UNITED STATES PATENT AND TRADEMARK OFFICE

Office Action Summary

09/602,525

1. The title of the invention is not descriptive. A new title is required that is clearly indicative of the invention to which the claims are directed.
2. The following title is suggested: Bracket assembly having plurality of plates for a dynamoelectric machine.

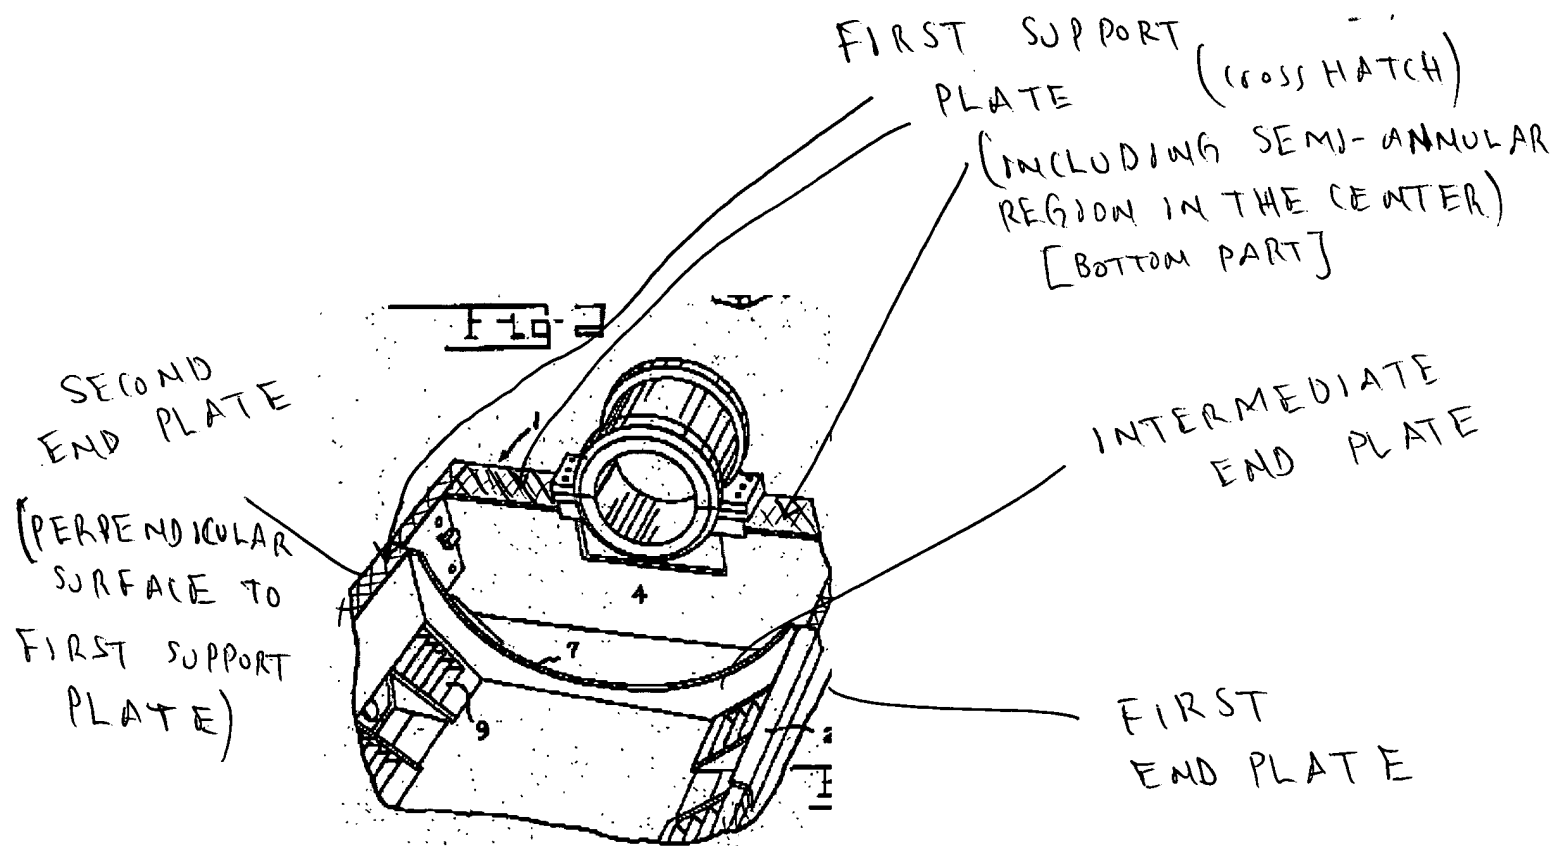
Michel et al discloses a bracket assembly, a stator 10 disposed in the frame, a rotor having shaft 5 within stator 14 (see figure 3), a bearing assembly (see figure 2) for supporting shaft 5 and a bracket assembly having a base (see figure 2), a support member 4, a first end plate and second end plate extending from base, support member 4 extending from base between first and second end plate and the first support plate extending from the first end plate to the second end plate and extending from the support member to a side plate and the support member connected to the first support plate form an enclosure and the side plate extends from the base plate to the first support plate (see illustration of figures 1 & 2 below/next pages).

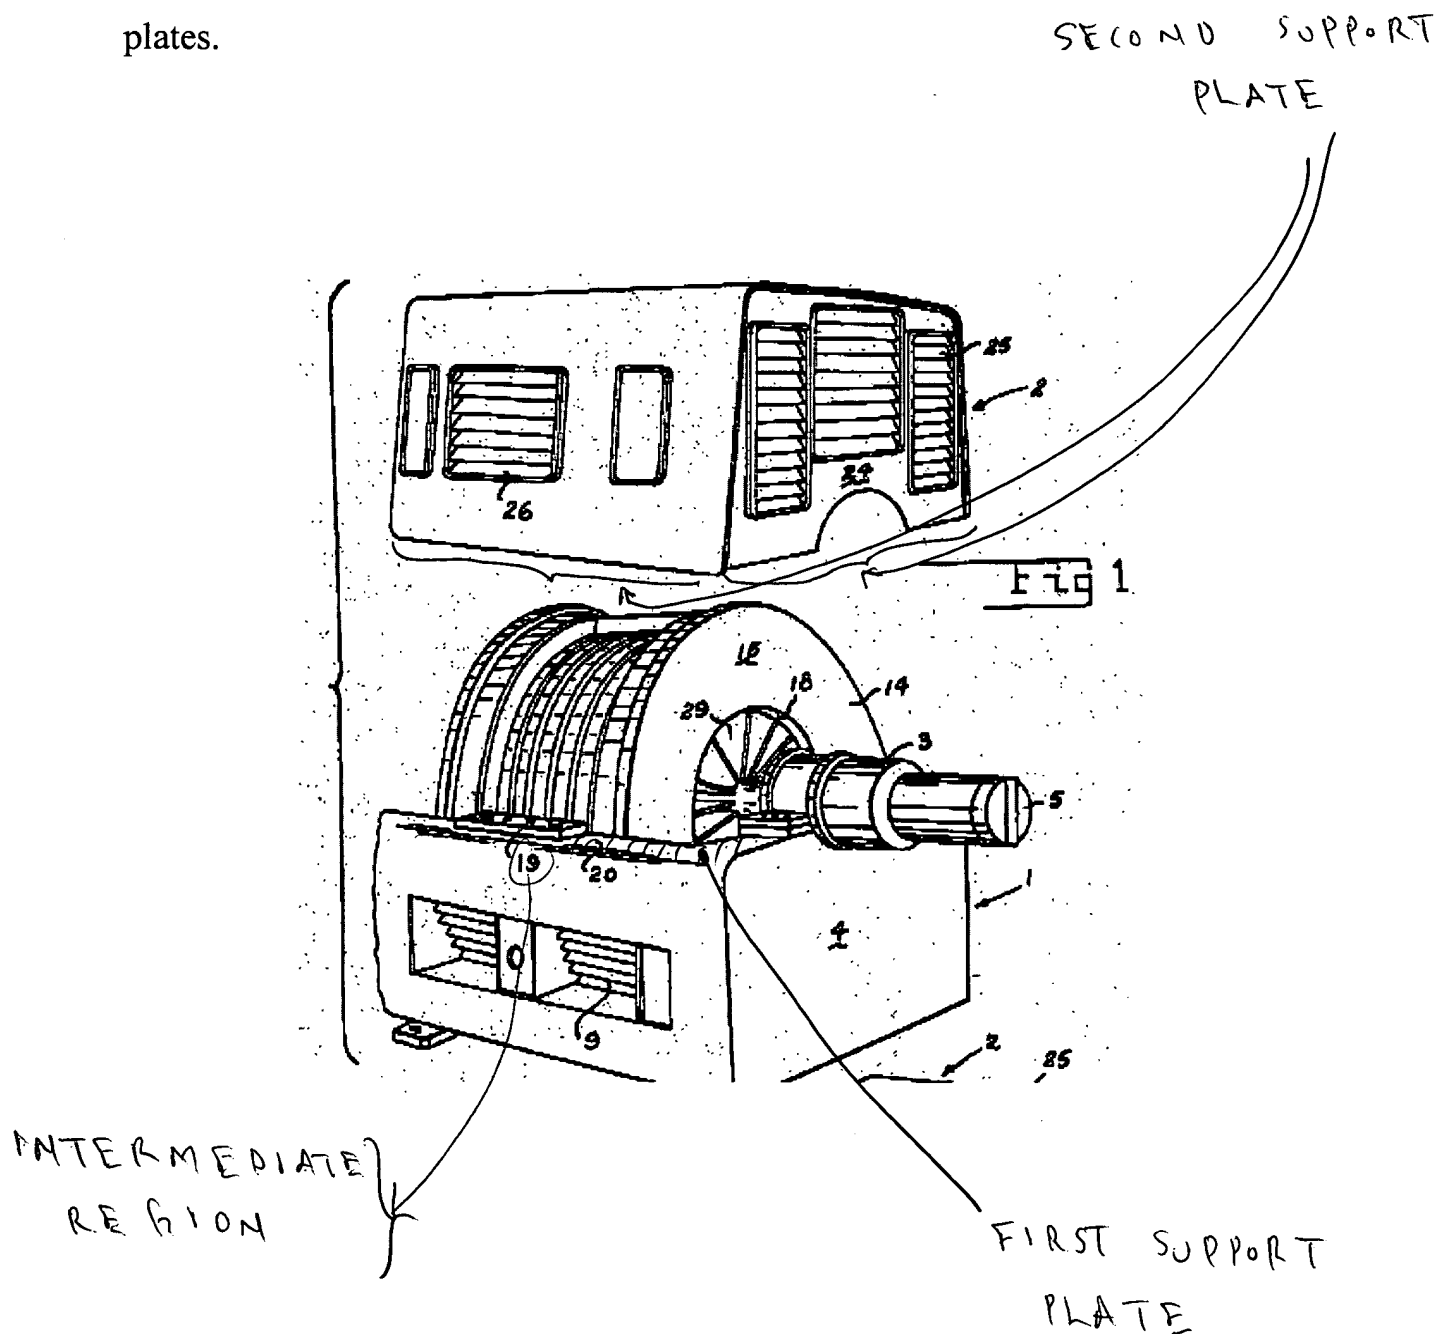
Moreover, Michel et al discloses that the base and first support plate are planar and parallel to each other. Also, an intermediate end plate 7 is disclosed located between first end plate and second end plate (see illustration of figure 2 below).

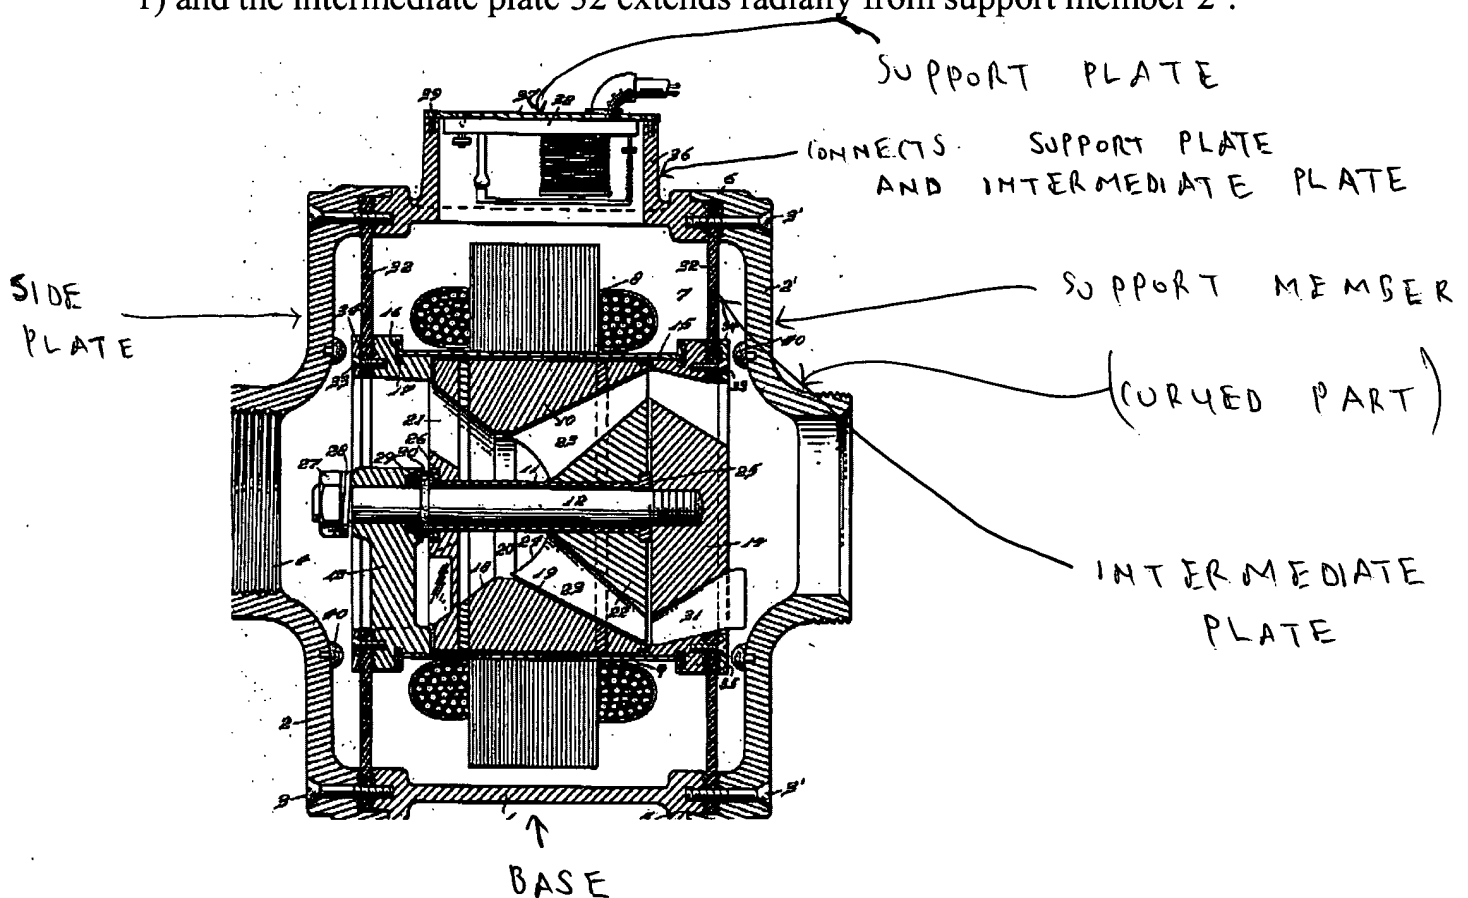
Also, there is disclose a plurality of support plates (bottom and top part of figure 1) and an intermediate region 19 extends between first and second support plates.
